**SPECIAL
PLANNING COMMISSION MEETING**
Monday, June 25, 2018 – 7:00 p.m.
City Council Chambers
23600 Liberty Street
Farmington, MI 48335

Description Final Site Plan Review - PUD Planned Unit Development: Liberty Hill, 32795 Ten Mile Road

LIBERTY HILL

RE: Liberty Hill – Final PUD Site Plan Review
Planning Review
32795 W. 10 Mile Road

Title:
Landscape Plan

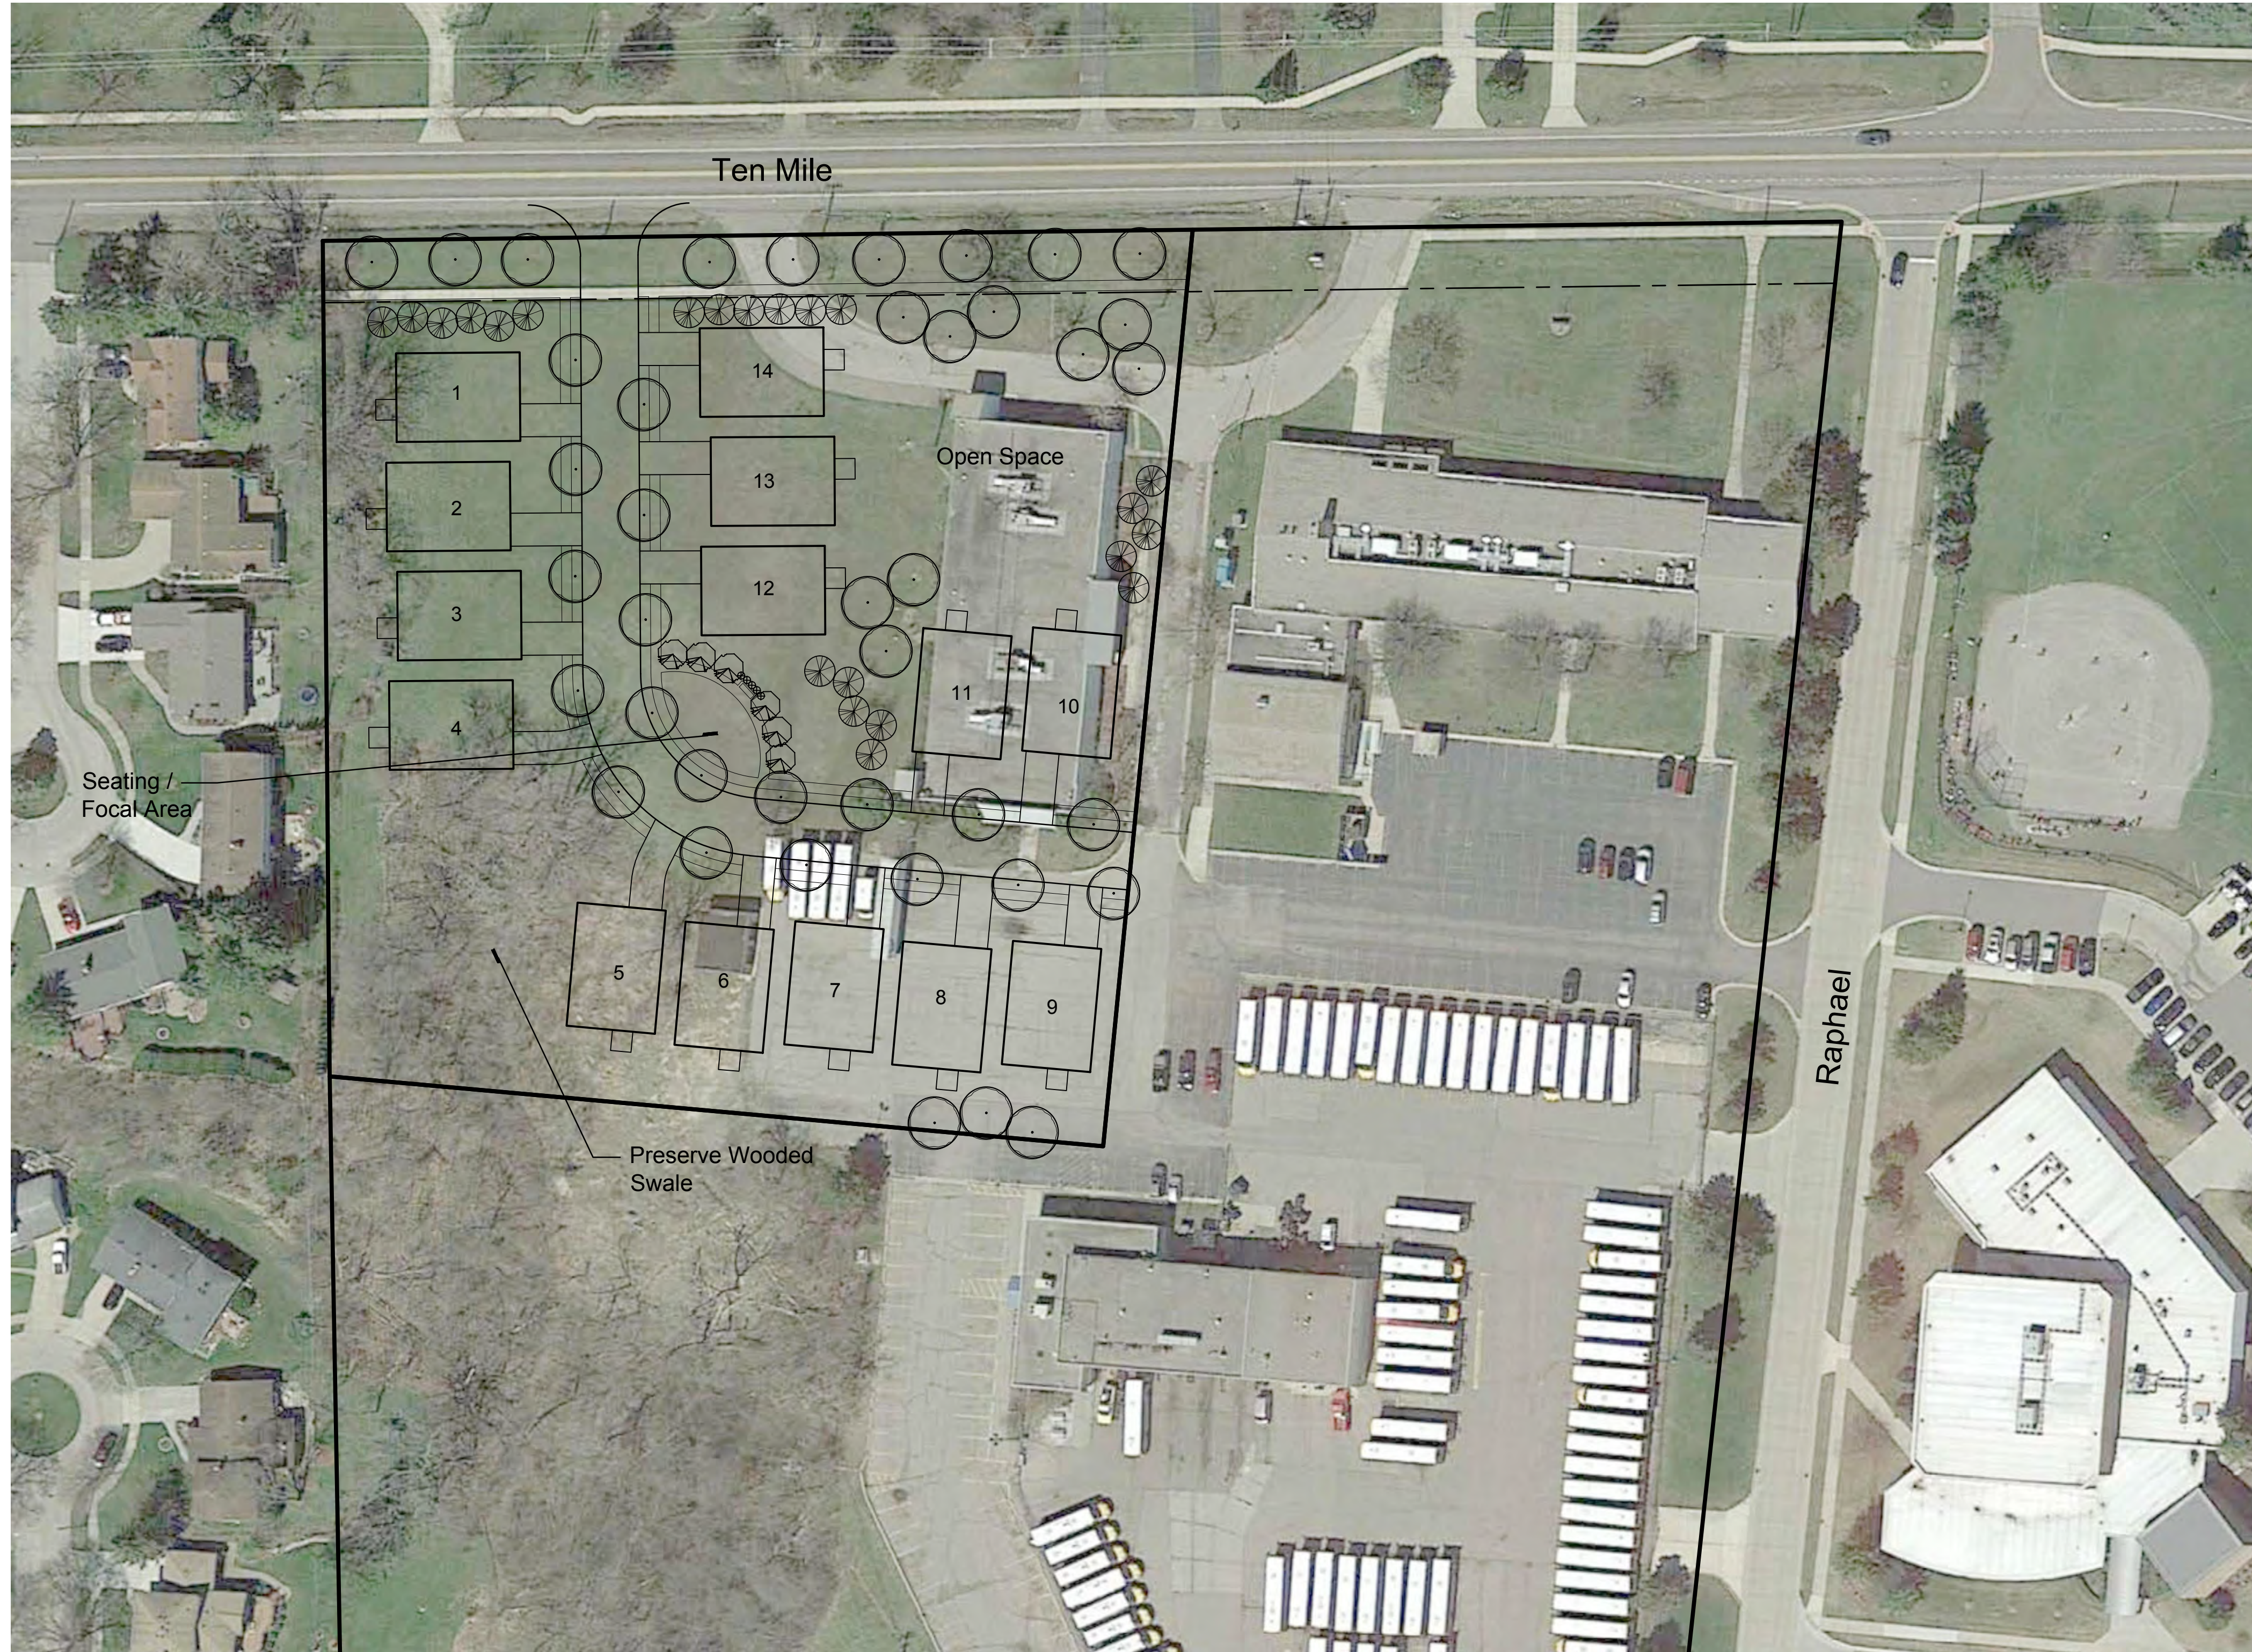
5. **Previous Comment:** *Dwelling unit details and other landscape design details (e.g. entrance sign, etc.) will need to be further developed for future submittals.*

- The current plan now shows a detail for the proposed entrance sign (Sheet L-1). Additional dimensions should be provided on the plans as outlined in Section 25 of the Code of Ordinance.
